Taylor Creek Culvert Replacement

Meeting Summary

This was the Seattle Design Commission's (SDC) first review of the Taylor Creek Culvert Replacement Project. The purpose of this meeting was to review the concept design for the project. After the presentation, questions, and deliberation, the SDC voted, 9-0, to approve the concept design for the Taylor Creek Culvert Replacement Project with several recommendations.

Concept Design

Figure 2: Natural area design concept

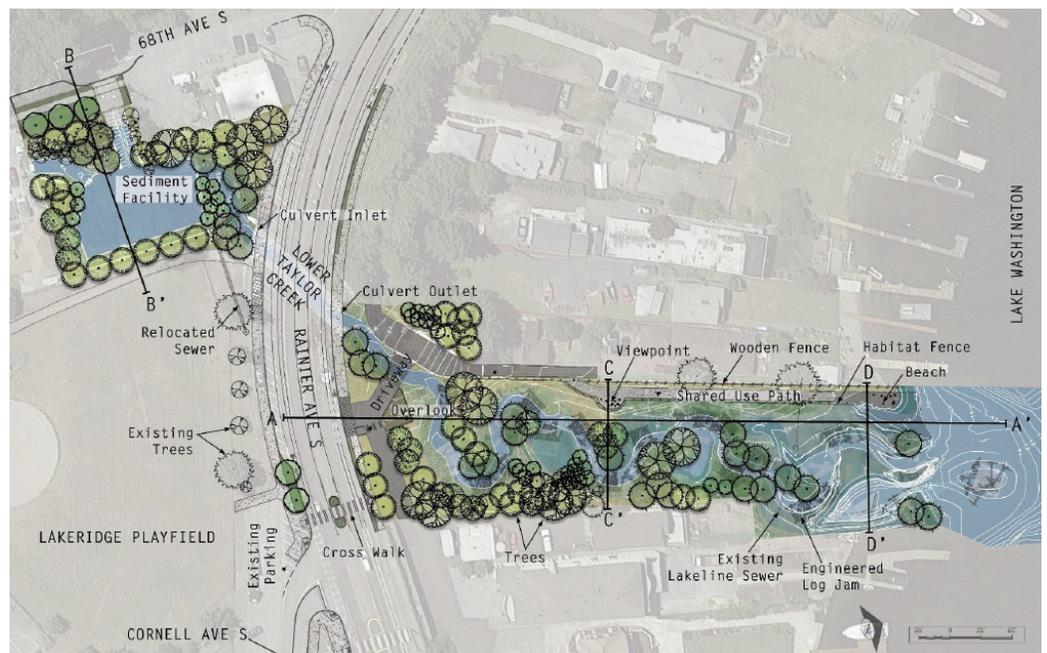
While the SDC commended the project team for designing a restoration project that includes public access, commissioners are very concerned that the pathway is not designed for universal accessibility. The commission strongly recommended the project team provide a pathway that is accessible for everyone. The SDC then encouraged the project team to prioritize ecological design and habitat restoration over pedestrian movement and strongly discouraged the use of ramping to provide universal accessibility as it would greatly impact the ecological design of the nature area. Instead, several commissioners encouraged the design team to, if possible, provide a universally accessible shared use pathway to the beach for pedestrians and maintenance vehicles along the northern edge of the nature area. Commissioners recommended the shared use pathway could include a turnaround area that, when not in use by maintenance vehicles, could also serve as drop off for disabled vehicles. Several Commissioners recommended the project team explore the feasibility of purchasing additional land north of the nature area to accommodate an accessible pathway.

The SDC then recommended the design team to integrate this portion of Rainier Ave S into the project design. Specifically, commissioners encouraged the project team to design a bridge that is perceived as crossing over a natural ecosystem rather than serving as a barrier. Several commissioners then mentioned the proposed bridge design should allow natural light to filter through to the creek below. The commission also recommended the design of the adjacent sidewalk should visually express elements of the natural system.

The Commission then encouraged the design team to provide wayfinding measures, additional to providing signage, so pedestrians know they can access the shared use pathway.

The SDC acknowledged the importance of providing educational opportunities throughout the project site. The commission recommended the project team include programming, such as educational and interpretation opportunities, near the bridge, viewpoint, and beach to create spaces that will encourage users to explore the site. Commissioners then recommended the design team consider long term maintenance when selecting plant and landscape materials.

1. Coordinate with SDOT to address the following issues:
 - Bridge design and fish passage
 - Traffic calming along Rainier Ave S
 - Quality of the pedestrian experience

1. Provide wayfinding that addresses public access routes, specifically west of Rainier Ave S
2. Consider providing alternative design concepts that address the feasibility of providing an accessible drop off point closer to the lake without negatively affecting the ecological benefit of the project.
3. Consider providing educational and interpretive elements along the pathway
4. Clarify the design intent of where viewpoints will be located along the pathway and understand how tree placement will affect the overall view
5. Explore the feasibility of purchasing additional land north of the nature area to accommodate an accessible pathway.
